SUBJECT: **ACTON / MAYNARD** - Assabet River
Rail Trail Construction, Includes 4 Bridges
Project File #604531
AAB/ADA 25% Accessibility Review

The following review is based on the 25% submission documents for the subject project.

SKETCH

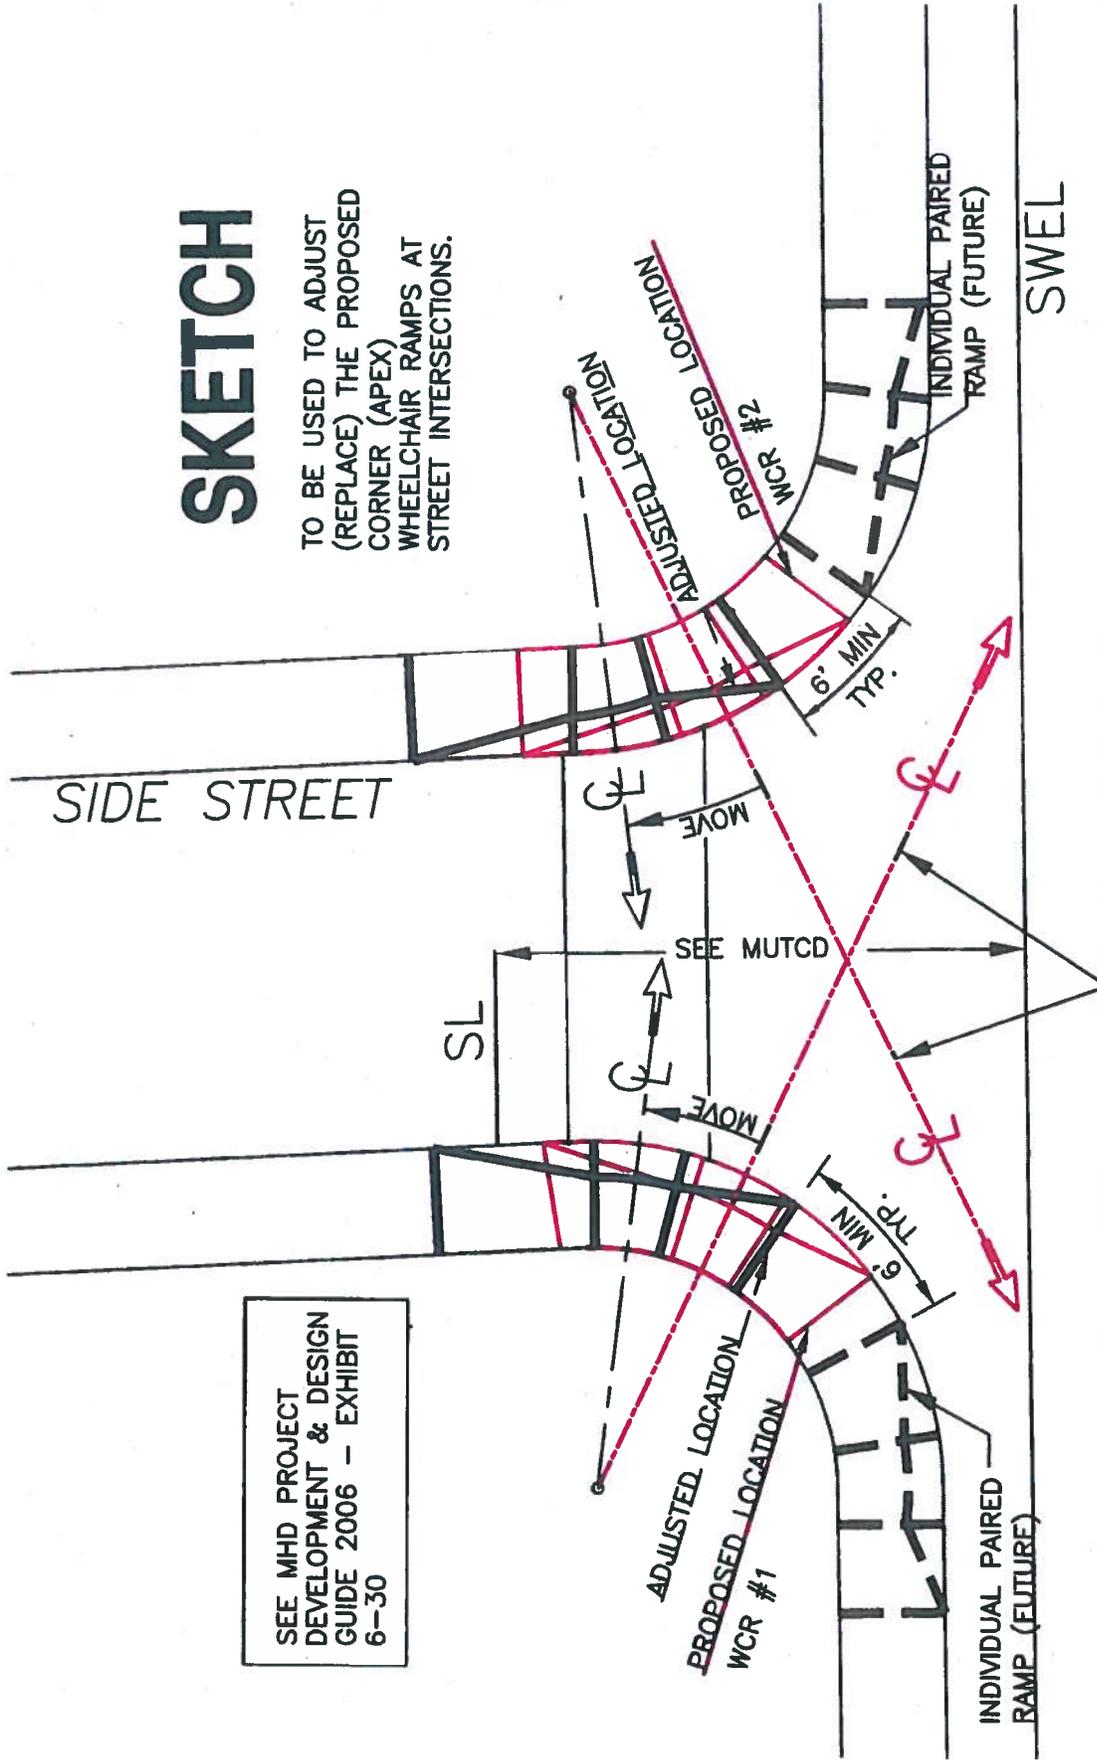
13. Wheel chair ramps can provide geometric wayfinding assistance to the visually impaired to correctly orientate them to the proper direction when crossing a street. Radial wheelchair ramps inherently interfere with this property and can direct the visually impaired into the traffic stream instead of directing them to properly cross the street within the cross walk markings. As a result, we direct the designers not to place a radial wheel chair ramp in the "apex location" of a turning radius, but rather, to shift the wcr along the curvature of the radius as much as allowable, up to a maximum allowable by the MUTCD, to help negate the effect of improperly directing the visually impaired into the traffic stream. Also, a 4 foot deep by the length of the width of the ramp landing area is required at the bottom of all ramps to be within the cross walk strips and outside of the through-travel lanes. Apex positioned wcrs are only allowed when there are site constraints.

Please move all the radial wcrs to provide the best possible wayfinding assistance for the visually impaired. (See attached sketch showing a general layout.) For example the proposed apex wcr at station 76+00. Please provide a separate wcr for each crossing direction.

TO BE USED TO ADJUST
(REPLACE) THE PROPOSED
CORNER (APEX)
WHEELCHAIR RAMP AT
STREET INTERSECTIONS.

BY MOVING THE CENTER LINES OF THE RAMP,
THE WHEELCHAIR RAMP AND THE USERS ARE
DIRECTED MORE ACROSS THE STREET AND LESS
TO THE INTERSECTION.
APPEARANCE CAN BE VERY IMPORTANT TO THE
DISABLED COMMUNITY ACCEPTANCE OF THE DESIGN
